Applicants : James A. Yurko et al.
Appln. No. : 10/761,911
Page :

In the Drawings:

The attached drawing sheet includes changes to Fig. 2. This sheet, which includes Figs. 1-2 replaces the original sheet including Figs. 1-2. Fig. 2 has been amended to include fan or blower 24 and to identify walls 22 as disclosed in the specification at paragraph 0029.

FIG. 2

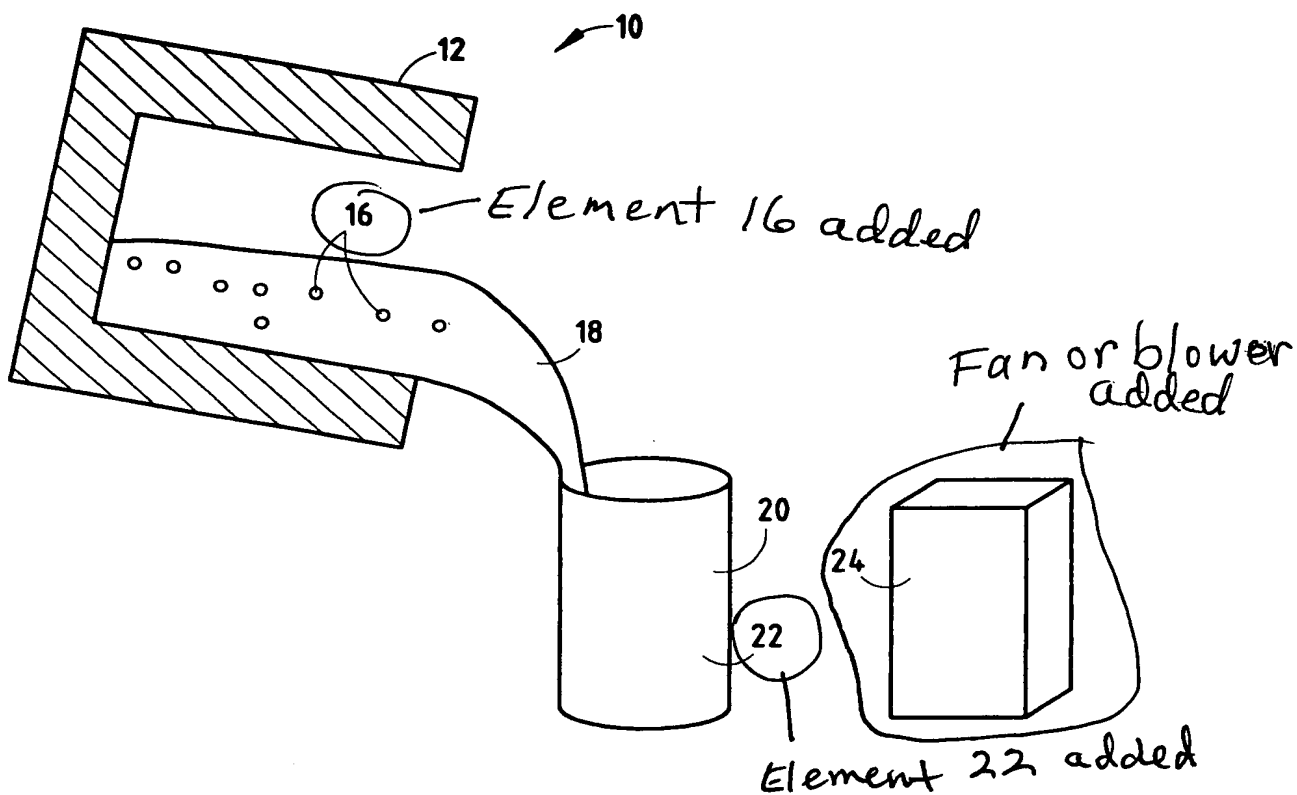
Applicants are enclosing a replacement sheet to in which Fig. 2 has been amended to include fan or blower 24 and to identify walls 22 as disclosed in the specification at paragraph 0029.
